TECHNICAL BULLETIN  
LTB00305NAS3  
25 MAR 2013

**SECTION: 308-07B**

Audible Boom / Vibration at 2,400 - 2,800 RPM

E131467

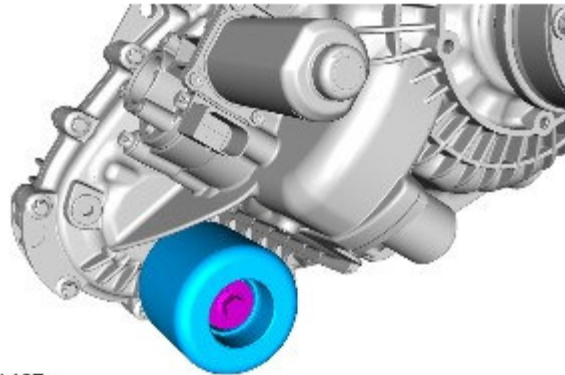
1. Raise and support the vehicle (see Workshop Manual section 100-02).
2. Install the damper and bolt to the vacant threaded hole in the transfer case.
  - Tighten the bolt to **75 Nm (55.5 lbf ft)**.
